Parker Hannifin Corporation

PRODUCT REFERENCE MEMO

40-77A, 40-77B, AND 40-77F WHEEL ASSEMBLIES, TIE BOLT / OVERHAUL SET AVAILABILITY

Figure 1 Lubricate the seals

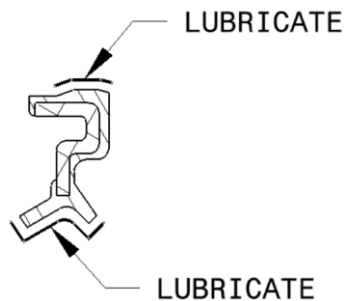
- (1) When returning the wheel assembly to service, apply a liberal amount of Mobile Aircraft grease SHC-100 to the bearings per PRM 78, the mating cavity areas, and lightly coat all contact surfaces of the grease seals (see Figure 1). Install rubber lip grease seals per PRM 97.
- (2) After installation of the wheel assembly on the aircraft, torque the axle nut to manufacturer's recommendation and secure with cotter pin as specified in the Airframe Owner's Handbook, install hubcap and secure with snap ring as applicable.
- (3) Make a logbook entry referencing the change of hardware Record the flight hours from the Hobbs meter, the length of time wheels have been in service, number of tire changes, the torque applied to the tie bolt nuts, inflation pressure, and date that the aircraft is returned to service.

Figure 2 New Configuration

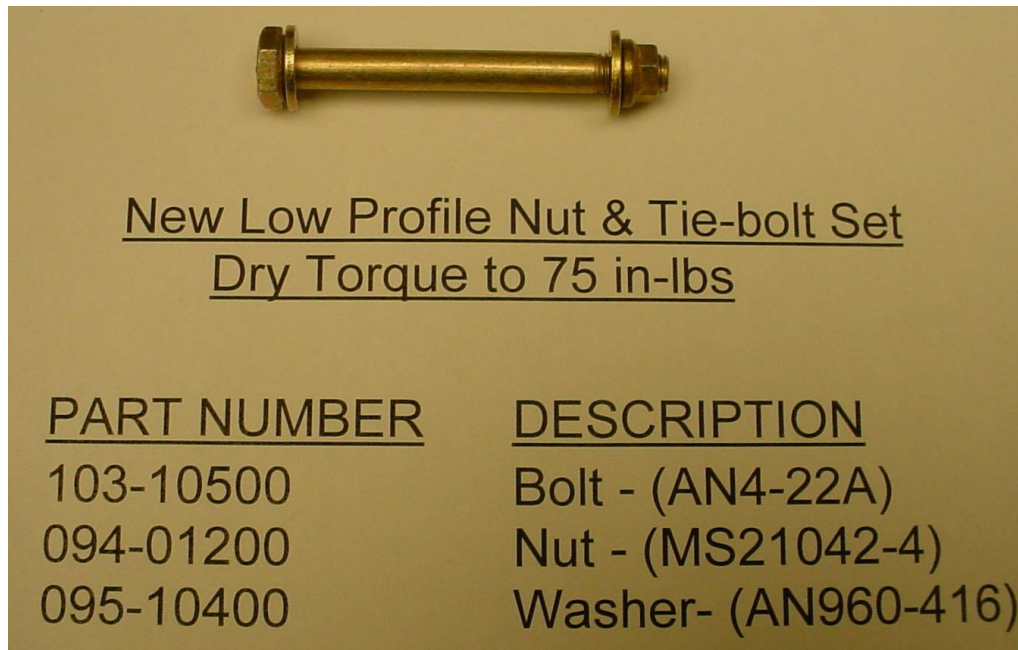
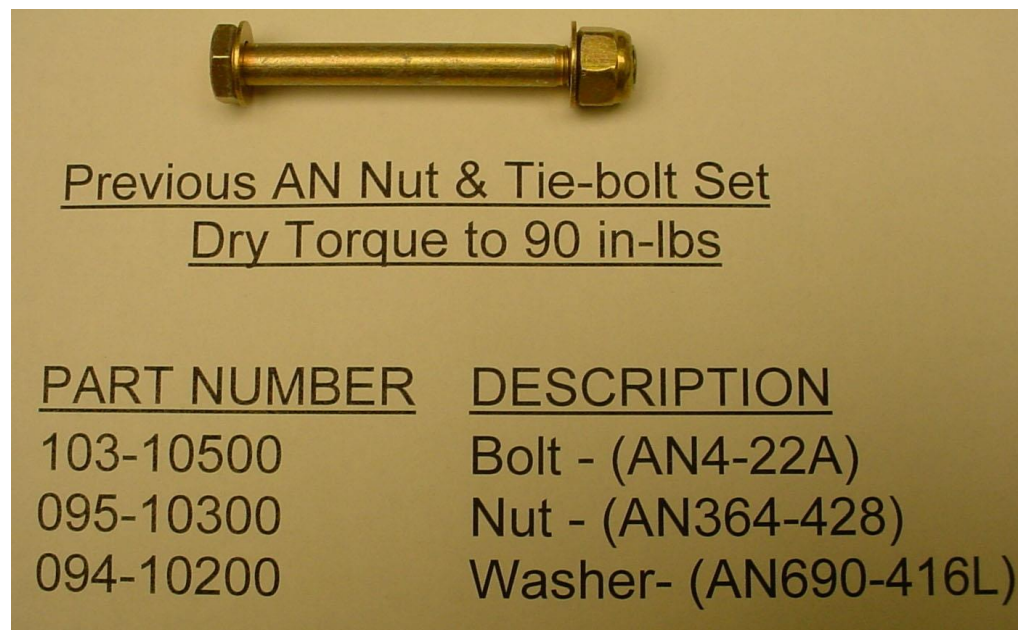
The original tie bolt system guidance from the 1972 standard, AC43.13.1A, Chapter 5, Section 1, Para 230 (a) (2), permits just the chamfer or round end of the bolt to be seen at the top of the nut. No failure has occurred as a result of this original tie bolt system.

Cleveland's current fastener design standard, AC43.13-1B, Chapter 7, Section 4, Para. 7-64 (f) recommends a minimum of one thread exposure above the nut.

Thus we are updating these assemblies with low profile all metal lock nuts that meet the minimum of one thread exposure above the nut under all conditions. The low profile nut provides distinct visual indication of proper thread engagement. Use of the existing nut is still an accepted configuration; however, a different torque value is required. Refer to Figures 1 and 2 for configuration examples.

- (1) At next tire change or overhaul replace the tie bolt set and incorporate the low profile nut per this Product Reference Memo.
- (2) At next available maintenance interval, and at Owner's discretion, inspect tie bolt system for evidence of one complete thread exposed from the nut. If one complete bolt thread is exposed above the nut, aircraft may be returned to service at Owner's discretion.

- (8) Reassemble wheel per maintenance manual instructions installing one (1) washer under each nut and DRY torque nuts in two steps; first to 35 in-lbs then to 75 in-lbs. ALWAYS restrain the bolt head and torque the nuts using a crisscross pattern until all nuts are properly torqued. Lubricant is **NOT** to be used.
- (9) Place Warning label adjacent to valve hole.
- (10) Place identification label opposite valve hole.
- (11) Reinstall wheel on aircraft per applicable aircraft manual.
